FURTHER ADVICE

APPLICATION NO: COM/40/2021
PROPERTY ADDRESS: 117 SCHOOL ROAD, LOGAN RESERVE QLD 4133,
115 SCHOOL ROAD, LOGAN RESERVE QLD 4133,
117 SCHOOL ROAD, LOGAN RESERVE QLD 4133,
242-248 LOGANVIEW ROAD NORTH, LOGAN
RESERVE QLD 4133, 250-258 LOGANVIEW ROAD
NORTH, LOGAN RESERVE QLD 4133, 115 SCHOOL
ROAD, LOGAN RESERVE QLD 4133
PROPERTY DESCRIPTION: LOT 26 SP 348491, LOT 25 RP 97736, LOT 26 RP
97736, LOT 40 RP 229101, LOT 41 RP 229101, LOT 25
SP 348490

- **COMBINED APPLICATION - MATERIAL CHANGE OF USE FOR A VARIATION REQUEST TO VARY THE EFFECT OF THE LOGAN PLANNING SCHEME 2015 (DWELLING HOUSE) AND RECONFIGURING A LOT (4 LOTS INTO 69 RESIDENTIAL LOTS, NEW ROADS AND PARK)**
-

DN150 Main and Boundary Valve

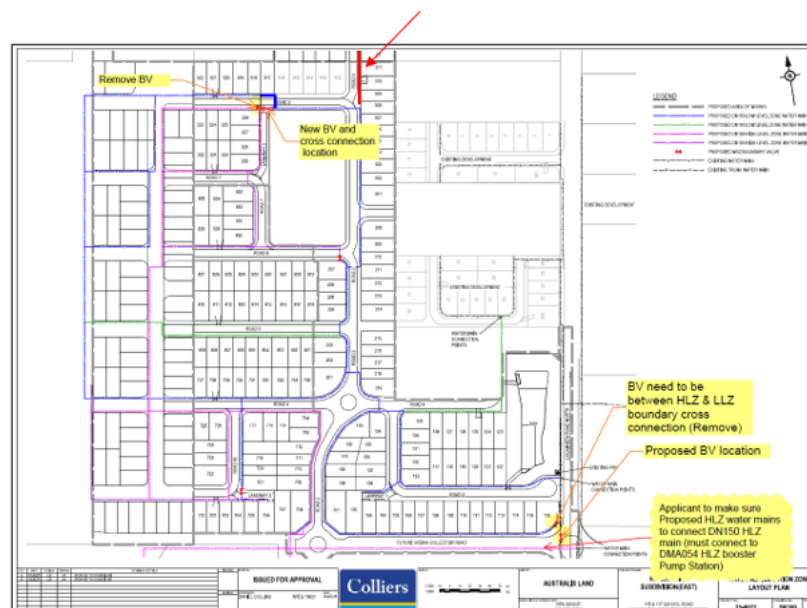
4.1. Revise the plan to demonstrate connection to the current, existing water network only. The updated plan must:

4.1.1. Show all required boundary valves to separate DMA zones and HLZ mains.

4.1.2. Include a DN150 water main connection with a closed WSZ boundary valve arrangement (X-O-X), as indicated in the sketch below.
